SUBJECT: Forwards rev 35 to "Turkey Point EP" & revised EPIP
 0-EPIP-20101, "Duties of EC," per requirements of 10CFR50,
 App E & 10CFR50.54(q). Summary of changes, encl. Implementation
 date for both documents was 990330.

Re: Turkey Point Units 3 and 4
Docket Nos. 50-250 and 50-251
Emergency Plan, and Emergency Plan Implementing Procedure, Revisions

SUMMMARY OF CHANGES
Turkey Point Radiological Emergency Plan, Revision 35

**FIGURE 4-1
COMMUNICATIONS INTERFACES**

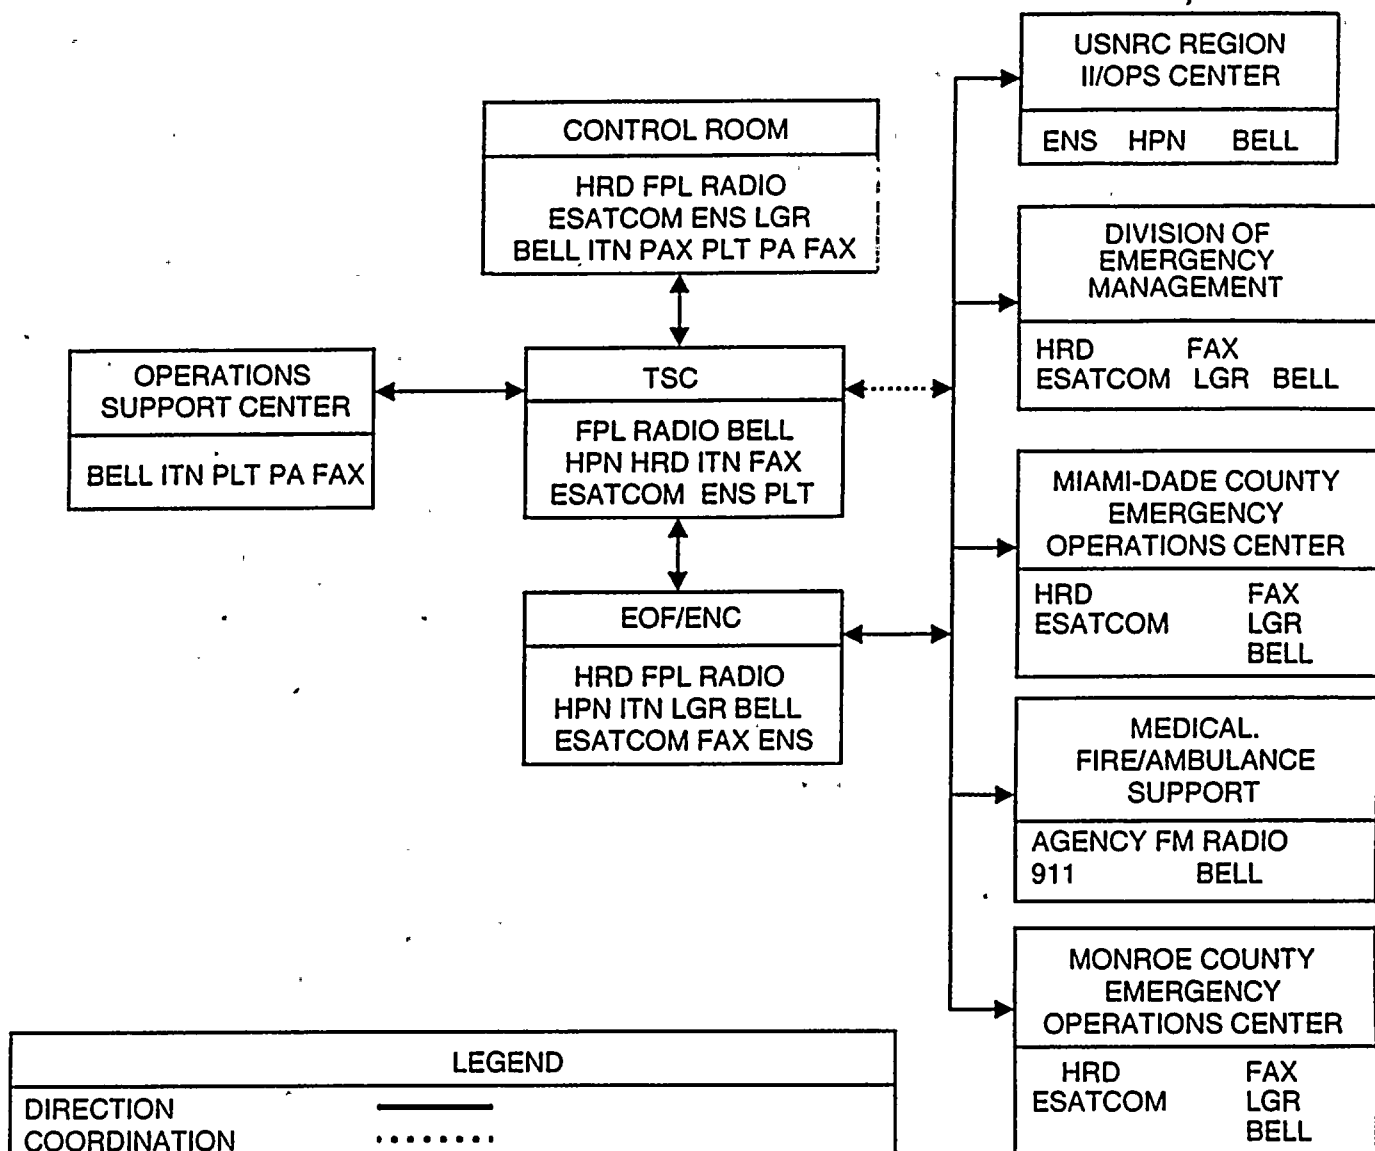
- Page 4-6 Figure 4-1, *Communication Interfaces*, added 911 and Bell telephone to Medical, Fire and Ambulance Support. These are two additional interfaces, which may be used to communicate with support agencies.

FIGURE 5-1

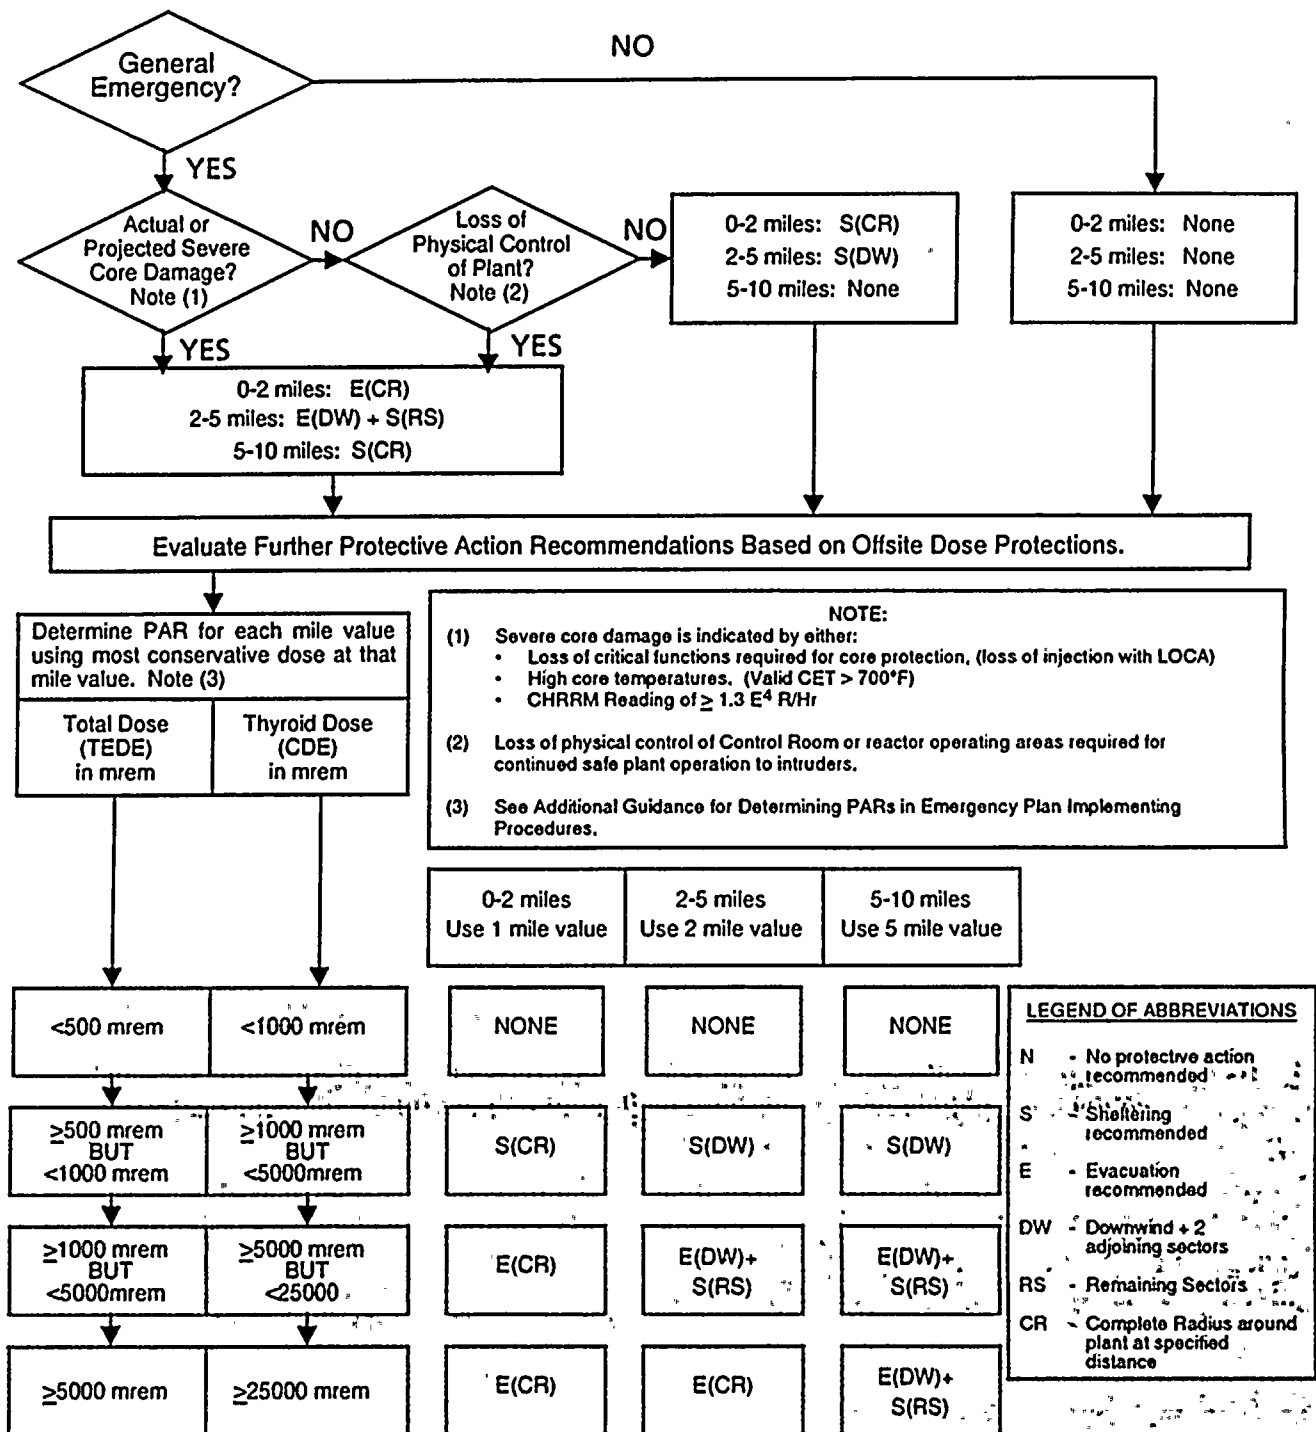
- Page 5-4 Section 5.1.5, Paragraph 2, deleted reference to NUREG 0654 as a guide for Protective Action Recommendations. Editorial change.
- Page 5-8 Figure 5-1, PAR Worksheet, deleted cross-arrows at bottom of sheet. These arrows were confusing to users and were improper. Editorial change.
